Technical product information

Topic	Coolant leaking from the mechanical coolant pump - Low coolant level warning - Engine overheating - DTC's evident
Market area	Russische Föderation (5RU), Australia E04 Bentley rest Asia and Australia (6E04), China 796 VW Import Comp. Ltd (Vico), Beijing (6796), Germany E02 Bentley rest Europe (6E02), Japan E03 Bentley Japan (6E03), Korea, (South) E08 Bentley South Korea (6E08), United Arab Emirates E06 Bentley Middle East and Africa (6E06), United Kingdom E01 Bentley UK (6E01), United States E05 Bentley USA and rest America (6E05)
Brand	Bentley
Transaction No.	2065919/5
Level	EH
Status	Approval
Release date

TPI 2065919/5 - Revised instructions to include the replacement the Solenoid for coolant circuit N492 (Figure 1 ARROW) in conjunction with the mechanical coolant pump

Figure 2

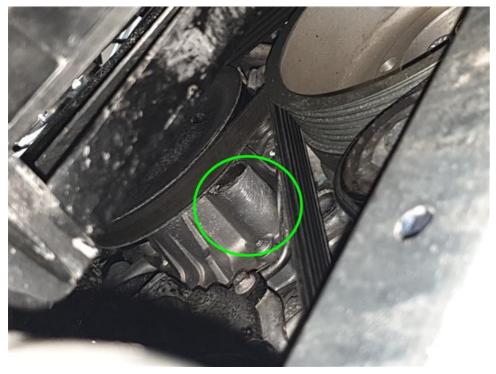
Refer to the video located within the Bentley Hub reference TPI 2065919/- this video shows an example of a coolant pump with no leak <u>although there is a small coolant witness mark evident (Figure 2)</u> in this scenario the coolant witness mark should be cleaned off (using a suitable cleaning agent) to the condition shown in Figure 3
